# Roundabout Canopy Coverage Update

JUNE 3 TREE  
BOARD MEETING

# SR-104 Roundabout at 40<sup>th</sup> Place NE & NE 184<sup>th</sup> Street

PROJECT NO.	221007
CONTRACT NO.	-
DRAWING NO.	EC02
SHEET	4
OF	89

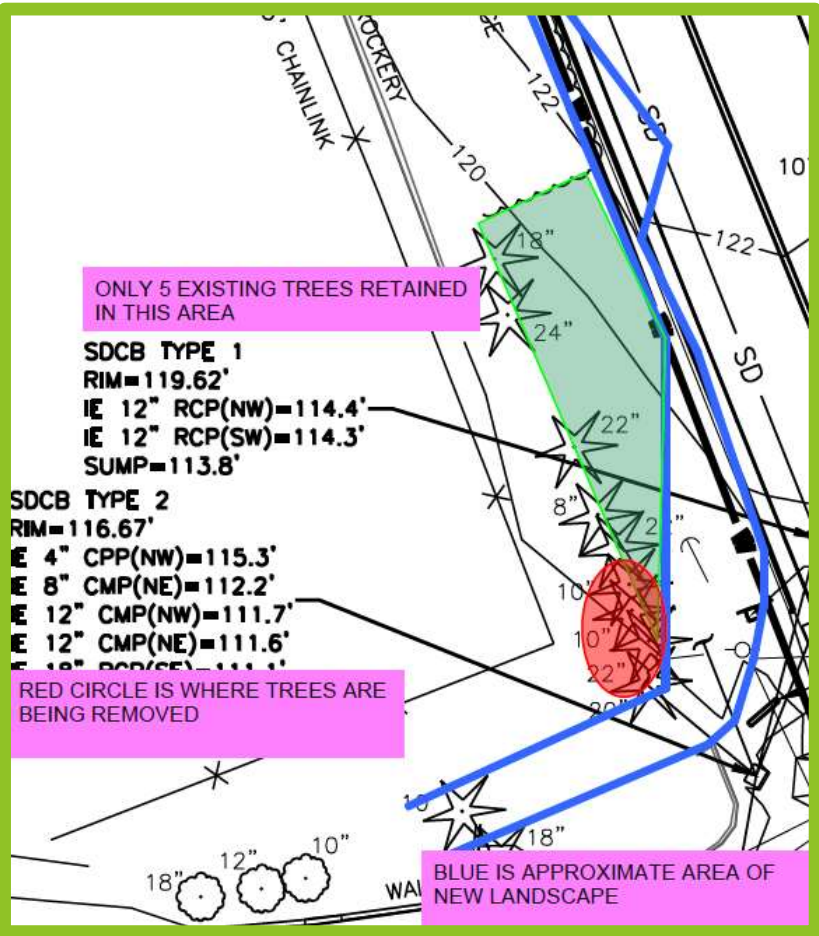
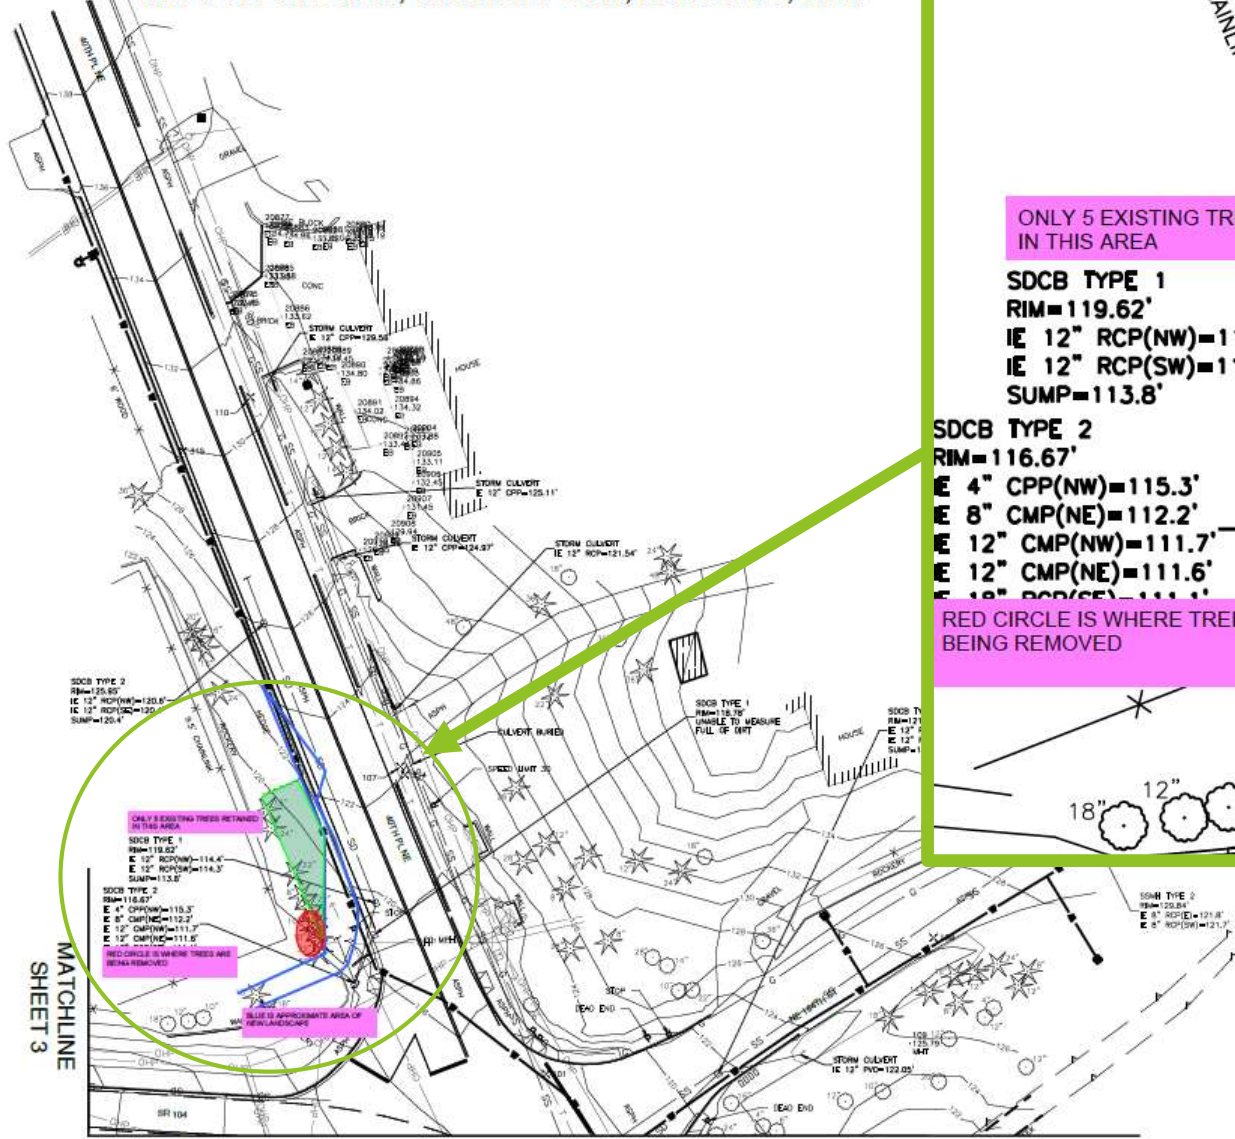
- ▶ This Douglas Fir is located at the NE quadrant of the Roundabout site, as shown by the star on the map to the right
- ▶ The removal of this tree has been approved by our Urban Forest Planner
- ▶ The removal of this tree will necessitate an additional 962 sqft of canopy coverage to be added to the project's canopy replacement plan
- ▶ In response to feedback received from the Tree Board, and in alignment with our City code, we plan to replace this canopy loss with new canopy coverage on the Roundabout project site, within the City's right-of-way

Star marks planting area at NW quadrant of Roundabout

RED CIRCLE IS WHERE TREES ARE BEING REMOVED

BLUE IS APPROXIMATE AREA OF NEW LANDSCAPE

Available planting area  
for 2-3 new trees is  
approximately 400 sqft

Canopy removed per design -15,660 sqft  
Canopy replacement per design +15,521 sqft

Additional canopy removed per contractor -962 sqft  
Additional canopy replacement required +1,101 sqft
